**Service Action: Remove Front Bumper Air Inlet Panel**

F30 (3 Series Sedan)

Produced from June 26, 2014 to July 4, 2014

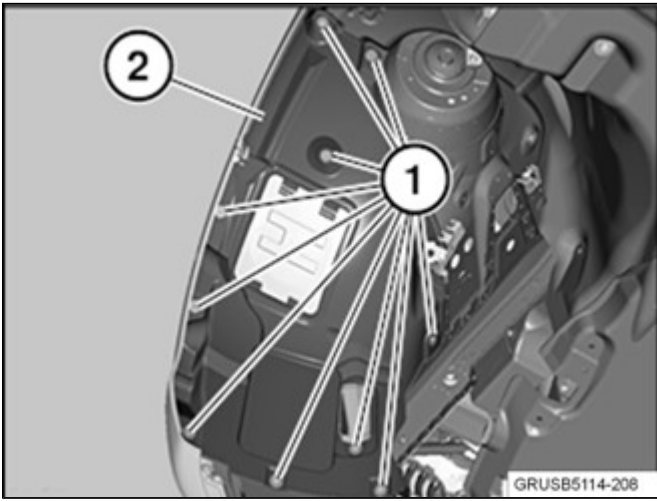
The front air cooling duct does not cool sufficiently. It may cause the engine to overheat, resulting in a Check Control message.

Certain vehicles were manufactured with a “sealed-off” front air cooling duct.

Remove the sealing panel from the front air cooling duct.

Remove the sealing panel in the air cooling intake duct and discard.

1. The sealing panel is located on the right side of the front bumper, behind the air cooling intake grill.

2. Remove the fasteners from the front section of the right front wheel arch liner (1) and remove the wheel arch liner (2).

3. Unclip the sealing panel from the air duct by using a suitable pry tool. Discard.

Reinstall the wheel arch.
